# Rezoning Transportation Analysis

Petition Number: 2018-058

General Location Identifier: 15716201, 15716202, 15716203, 15716204

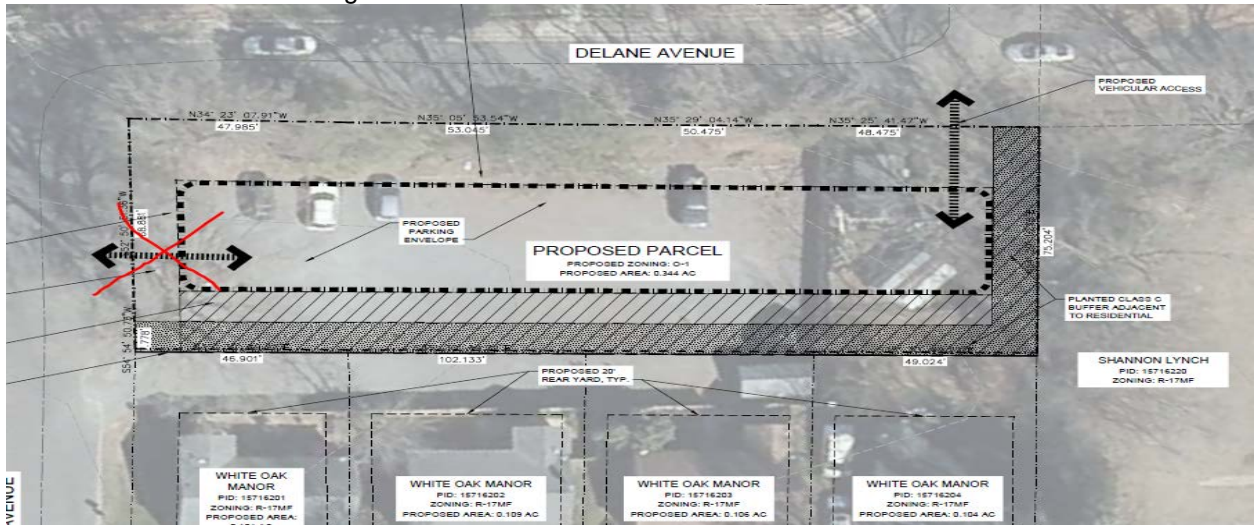
1. **Traffic Study** A Traffic Impact Study/Transportation Technical Memorandum is not necessary for the complete review of this petition.
2. The petitioner should revise the site plan and conditional note(s) to add curb and gutter along the frontage on Delane Avenue.

3. The petitioner should revise the site plan and conditional note(s) to remove proposed access on west side of site and utilize existing access.

4. The petitioner should revise the site plan to show the layout of the parking lot.
5. The petitioner should revise the site plan and conditional note(s) to show 8' planting strip and 6' sidewalk along northern side of property and 8' back of curb sidewalk along west side of property and continue 8' sidewalk to intersection.

6. The petitioner should revise the site plan to add a note specifying dedication and fee simple conveyance of all rights of way to the City before the site's first building certificate of occupancy is issued. CDOT requests right of way set at 2' behind back of sidewalk where feasible.

7. The petitioner should revise the site plan to add a note specifying all transportation improvements will be approved and constructed before the site's first building certificate of occupancy is issued. The petitioner may phase transportation improvements if said improvements and phasing are explicitly described in site plan notes.
